A meeting of the **WAVERLEY LOCAL PLANNING PANEL** will be held by video conference at:

12.00PM WEDNESDAY, 22 JUNE 2022

WLPP-2206.1 PAGE 4 607/109 Oxford Street, BONDI JUNCTION NSW 2022 - Alterations and additions to Unit 607 of shop top housing development, including extension of living room and reduction of balcony size. (DA-2/2022)

WLPP-2206.2 PAGE 28 21 Castlefield Street, BONDI NSW 2026 - Review of decision seeking construction of a hardstand carparking space and driveway to the front of dwelling (DA-327/2021/1)

Figure 3: Minimum requirement for a hardstand car space shown in green

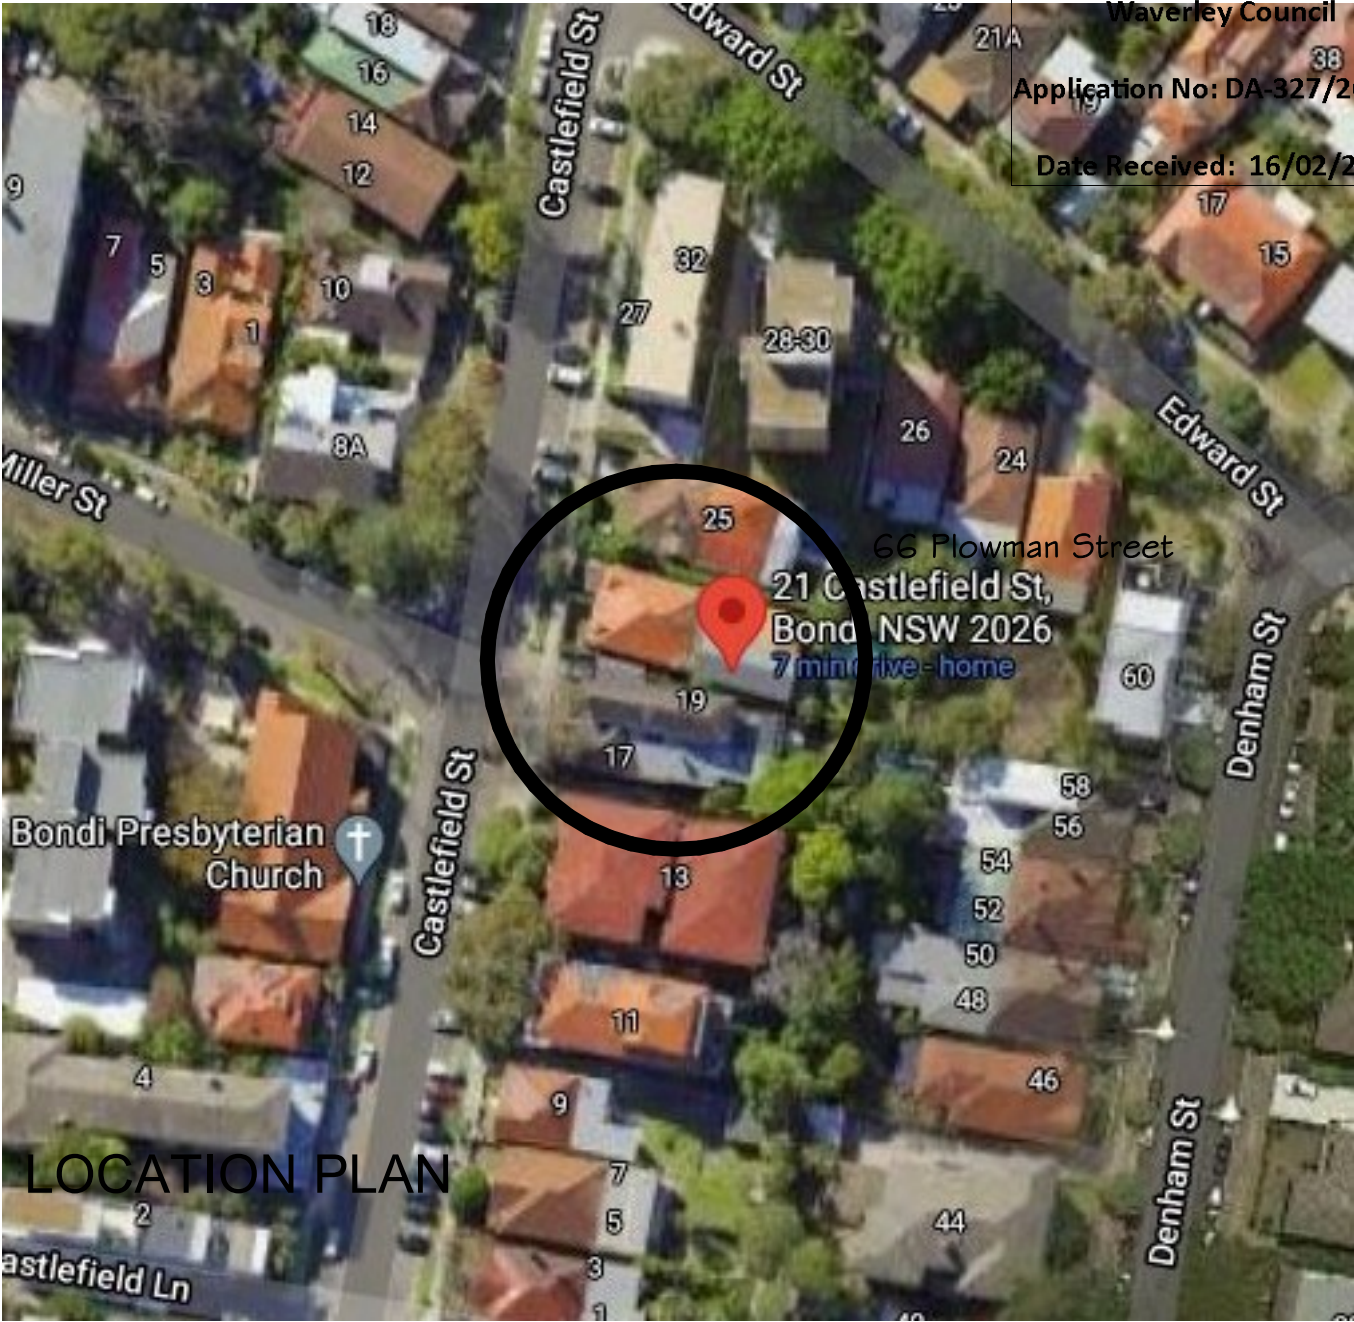
Council's Traffic Engineer has reviewed the proposal and does not support the proposed hardstand area as the hardstand does not comprise sufficient width to accommodate a car. The required area (including sufficient clearance) for a hardstand area to satisfy Council's car parking requirements should measure 5.4m in length and 2.4m in width, with an additional 0.3m clearance adjacent to a wall, as shown in the Figure 3 below.

Plan of Proposed Hardstand Carspace

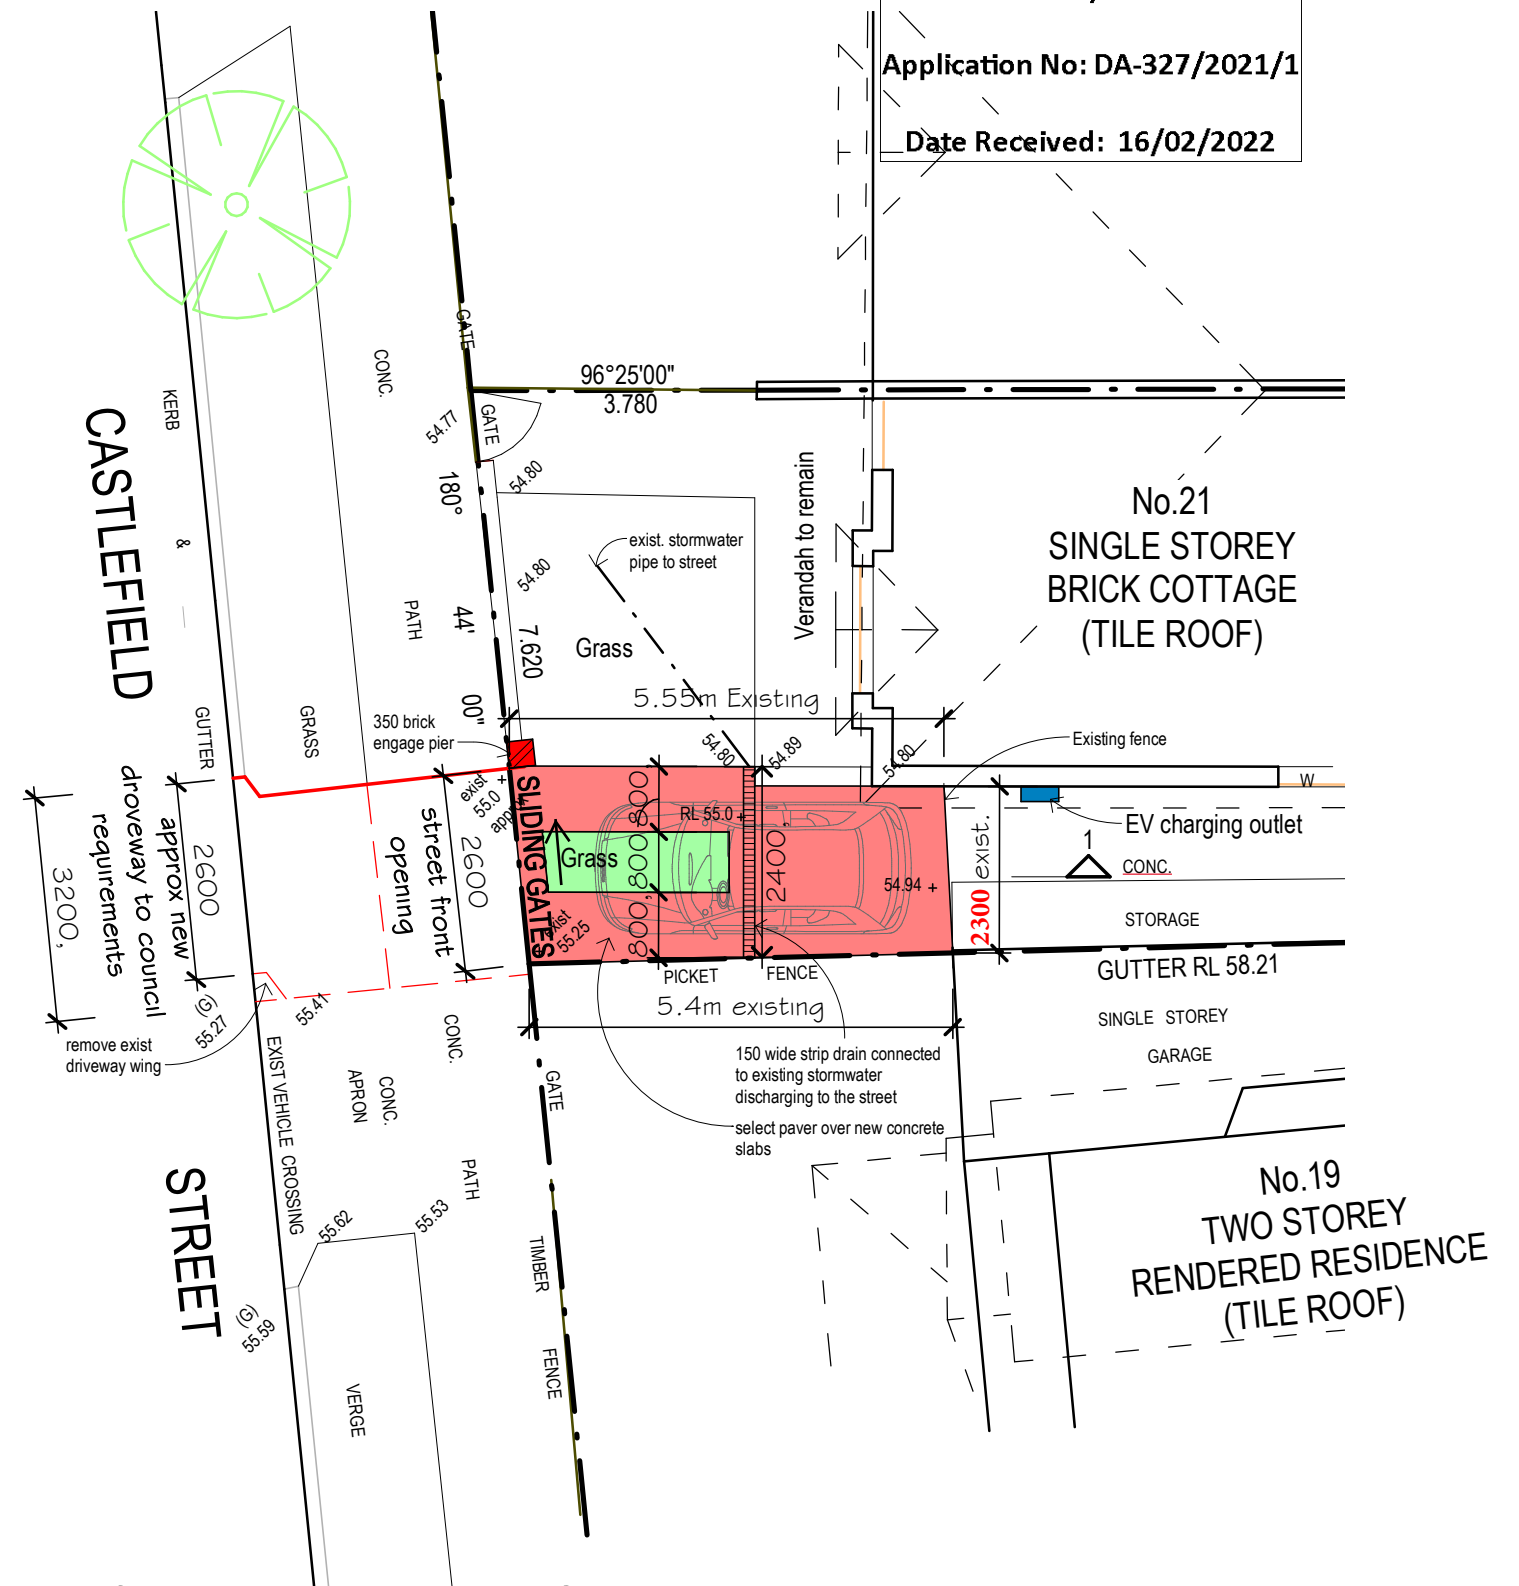
The assessment finds the issues of refusal have not been adequately addressed in this review application as the hardstand area still does not provide sufficient width to accommodate a vehicle within front setback.

1 June 21st 9.00am Existing

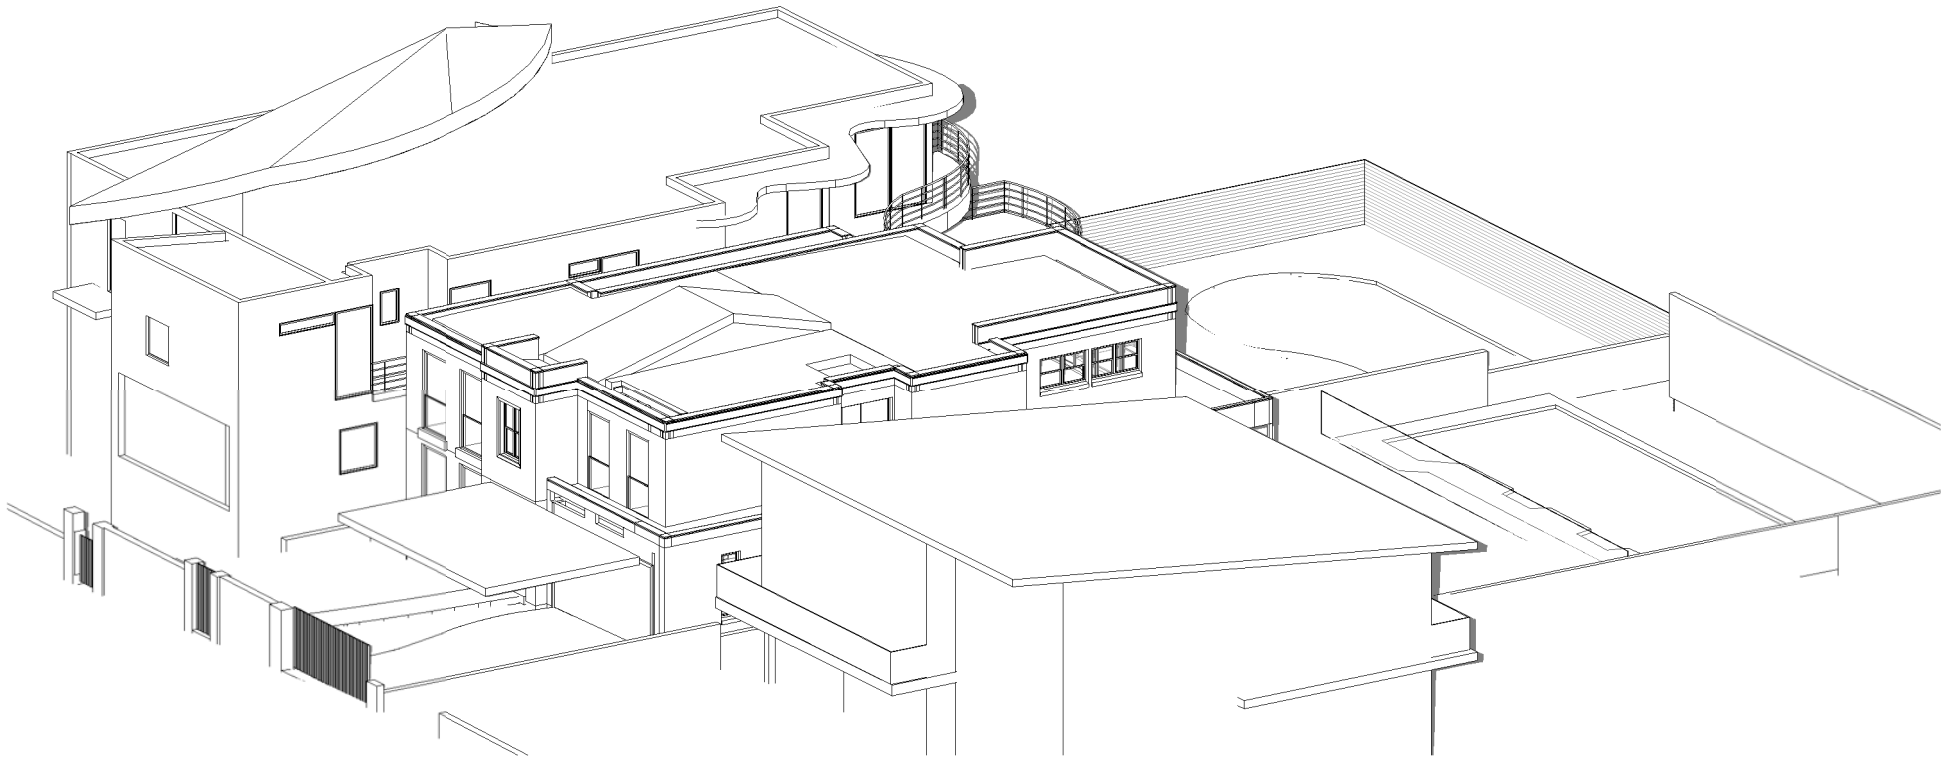
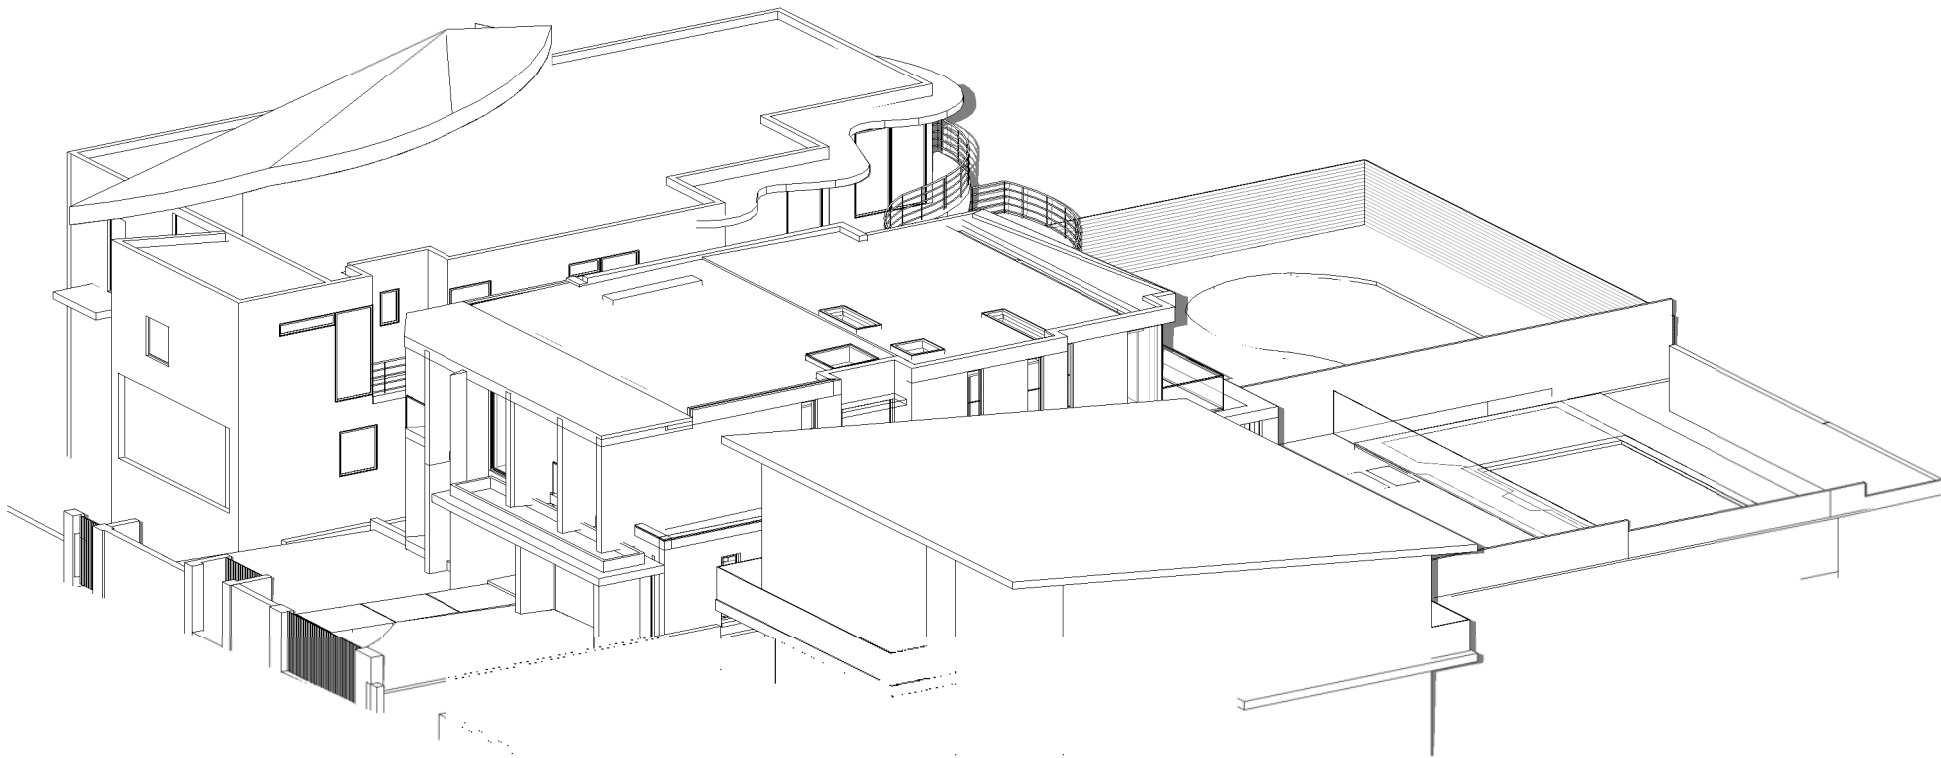
Lastly, the bulk and scale of the development have been significantly reduced compared to the original form of the proposal to minimise the 9am shadowing of the private open space of 17-19 Portland Street to an acceptable level. It is noted that only a small portion or corner of the rear deck is shadowed from the proposed development, however as this is not the principal private open space it is accepted. The proposal also retains current levels of sunlight to all north-facing windows of the neighbouring southern dwelling house at 17 Portland Street during mid-winter (refer to **Figure 6** of this report).
